Subject: McIntosh Frontage and Concept layout on Dawson parcel to east

Re: Dawson's Ridge Subdivision Exception Request for Arterial Setback

CONCEPTUAL LOT LAYOUT FOR:
DAWSON PROPERTY

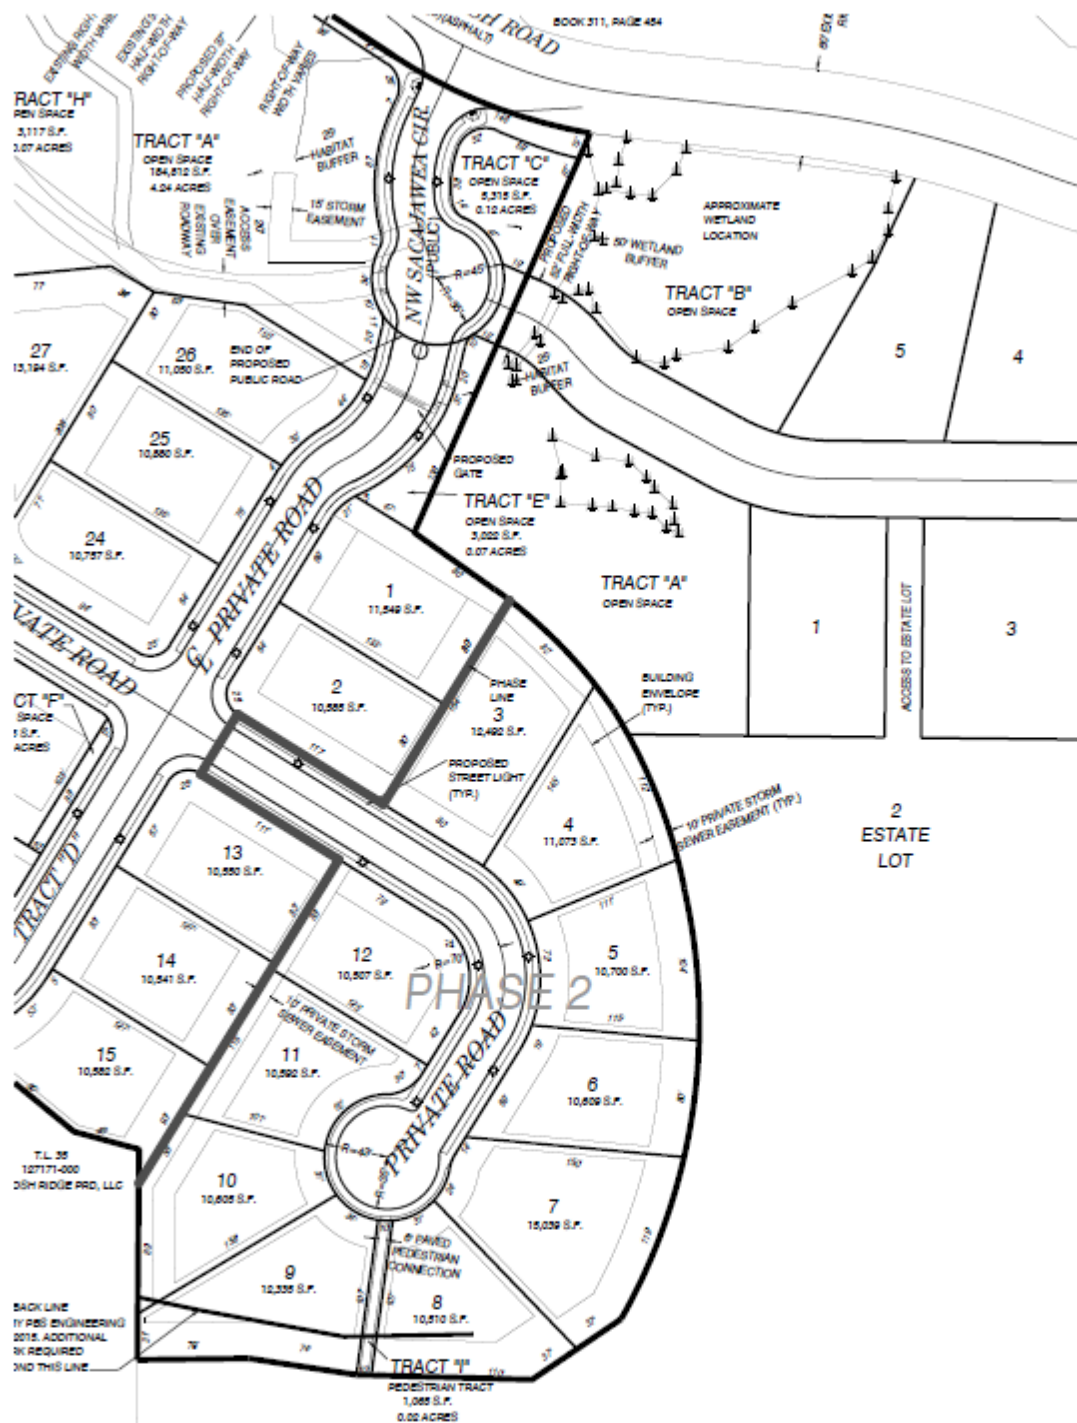
There was also discussion about the intersection spacing for the potential road stub to the east in the interior of the subdivision in regards to the 300' standard. I've attached the previously submitted road exception regarding this. I've also attached a concept layout for the Dawson parcel to the east. The potential intersection was placed to allow a road to be extended east between the offsite wetlands and allow lots to be accessed on both sides of the road. Essentially a standard double loaded road similar to many other projects in Camas. There are two examples of this on the north side of McIntosh that are depicted on the attached frontage improvement plan, Hidden Leaf and Brady Woods.
